Access Compliance Report Public Rights-of-Way (Pedestrian Signals)

Main Street: **NEWLAND_ST** Cross Street: **BOLSA_AVE** Location: **NW**

ADA ID: **SGRK210929125617** Signal Type: **One Push Button-Non APS** Overall Compliance: **No** Severity Scores: **BTN 1: 35** **BTN 2: N/A** **No BTN: N/A**

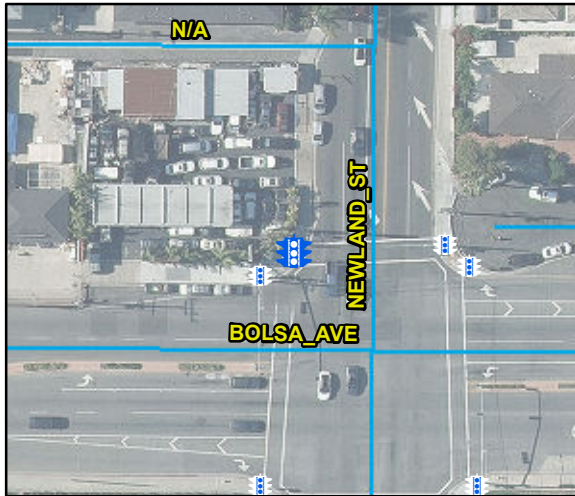
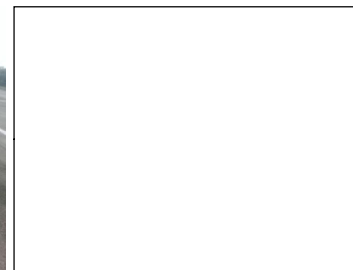
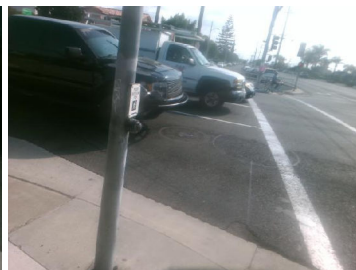
Compliance	Description	Data	Compliance	Description	Data
Button Count		Button1	Yes	Distant to Additional Button (in)	260
Additional Button Present?		Yes	N/A	Additional Button ID	SGRK210929125814
Located In An Island/Median?		No			
N/A B 1 Sign Present?		Yes	N/A	B 2 Sign Present?	N/A
Yes B 1 Sign Purpose?		Yes	N/A	B 2 Sign Purpose?	N/A
Yes B 1 Sign Lettering & Contrast?		Yes	N/A	B 2 Sign Lettering & Contrast?	N/A
Yes B 1 Parallel To XWalk?		Yes	N/A	B 2 Parallel To XWalk?	N/A
N/A B 1 PAR to Button?		N/A	N/A	B 2 PAR to Button?	N/A
N/A B 1 PAR to XWalk?		N/A	N/A	B 2 PAR to XWalk?	N/A
Yes B 1 Clear Floor Space?		Yes	N/A	B 2 Clear Floor Space?	N/A
N/A B 1 FWD Approach?		N/A	N/A	B 2 FWD Approach?	N/A
N/A B 1 FWD Approach Constrained?		N/A	N/A	B 2 FWD Approach Constrained?	N/A
N/A B 1 FWD Approach Reach (in)		N/A	N/A	B 2 FWD Approach Reach (in)	N/A
N/A B 1 FWD Approach Width (in)		N/A	N/A	B 2 FWD Approach Width (in)	N/A

N/A B 1 FWD Approach Obstruction?		N/A	N/A	B 2 FWD Approach Obstruction?	N/A
N/A B 1 FWD Approach Obstruction Dist (in)		N/A	N/A	B 2 FWD Approach ObstructionDist (in)	N/A
N/A B 1 PARA Approach?		N/A	N/A	B 2 PARA Approach?	N/A
N/A B 1 PARA Approach Constrained?		No	N/A	B 2 PARA Approach Constrained?	N/A
Yes B 1 PARA Approach Reach (in)		0	N/A	B 2 PARA Approach Reach (in)	N/A
N/A B 1 PARA Approach Width (in)		N/A	N/A	B 2 PARA Approach Width (in)	N/A
N/A B 1 PARA Approach Obstruction?		No	N/A	B 2 PARA Approach Obstruction?	N/A
N/A B 1 PARA Approach Obstruction Dist (in)		N/A	N/A	B 2 PARA Approach Obstruction Dist (in)	N/A
No B 1 Clear Floor Space Slope (%)		3.5	N/A	B 2 Clear Floor Space Slope (%)	N/A
No B 1 Clear Floor Space XSlope (%)		2.6	N/A	B 2 Clear Floor Space XSlope (%)	N/A
N/A B 1 PAR Slope (%)		0.8	N/A	B 2 PAR Slope (%)	N/A
Yes B 1 Height (in)		48	N/A	B 2 Height (in)	N/A
Yes B 1 Pressure (#)		5	N/A	B 2 Pressure (#)	N/A

Yes B 1 Closed Fist Operation?		Yes	N/A	B 2 Closed Fist Operation?	N/A
Yes B 1 Diameter (in)		2	N/A	B 2 Diameter (in)	N/A
N/A B 1 Crossing Direction		E	N/A	B 2 Crossing Direction	N/A
No B 1 DistanceTo XWalk (in)		68	N/A	B 2 DistanceTo XWalk (in)	N/A
Yes B 1 DistanceTo Curb (in)		30	N/A	B 2 DistanceTo Curb (in)	N/A
Parcel Identification Number		097-144-19			
Google Street View Link

Possible Solutions: Replace Signal Push Button With APS Button. Remove & Relocate Sign.
